# Access Compliance Report

## Public Rights-of-Way

### (Curb Ramps)

Intersection ID: 2899	Main Street: RIDGE_RD	Cross Street: WAVERLY_LYNN_LN	Location: NE
ADA ID: 9BA6ACA9C1DB	Ramp Type: Perp	Initial Pass/Fail: Fail	Overall Compliance: No
Severity Score: 10			
Codes/Mitigation Info/Possible Solution		Field Measurements/Component Compliance

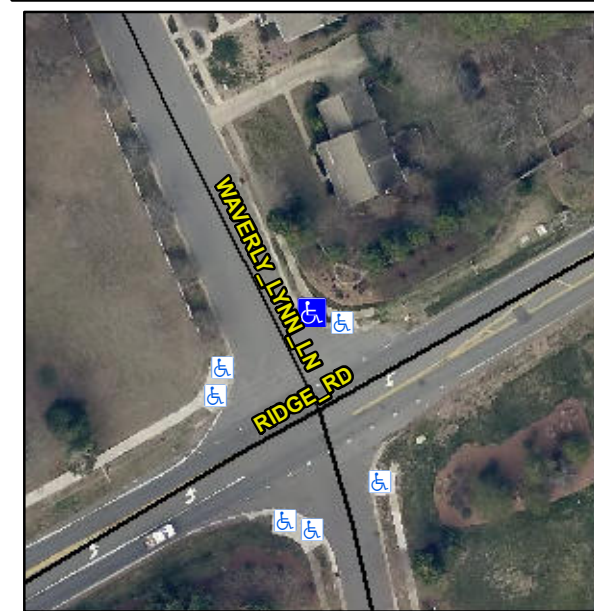
**N/A**

**R304.5.1, R304.5.3**

Compliance	Description	Data	Compliance	Description	Data
N/A	Ramp Length (in)	98.0	Yes	Ramp Slope (%)	5.2
No	Ramp Width (in)	41.0	No	Ramp XSlope (%)	3.1
N/A	Flare Type LT	N/A	N/A	Flare Type RT	N/A
N/A	Flare Slope LT (%)	N/A	N/A	Flare Slope RT (%)	N/A
N/A	Flare Traversable LT?	N/A	N/A	Flare Traversable RT?	N/A
N/A	Landing Length (in)	N/A	N/A	DWS Provided?	N/A
N/A	Landing Width (in)	N/A	N/A	DWS Contrast?	N/A
N/A	Landing Slope (%)	N/A	N/A	DWS Length (in)	N/A
N/A	Landing X Slope (%)	N/A	N/A	DWS Full Width?	N/A
N/A	Landing Curb? (Y/N)	N/A	N/A	DWS Offset (in)	N/A
N/A	Shared Landing?	N/A			
N/A	Gutter Ponding?	N/A	N/A	Gutter Slope (%)	N/A
N/A	Gutter Lip Ht (in)	N/A	N/A	Gutter X Slope (%)	N/A
N/A	Painted X Walk1?	No	N/A	Painted X Walk2?	N/A
	X Walk 1 Direction	To W		X Walk 2 Direction	N/A
N/A	X Walk 1 Width (in)	N/A	N/A	X Walk 2 Width (in)	N/A
	X Walk 1 Slope (%)	7.9		X Walk 2 Slope (%)	N/A
	X Walk 1 X Slope (%)	1.0		X Walk 2 X Slope (%)	N/A

**Remove & Replace Entire Ramp.**
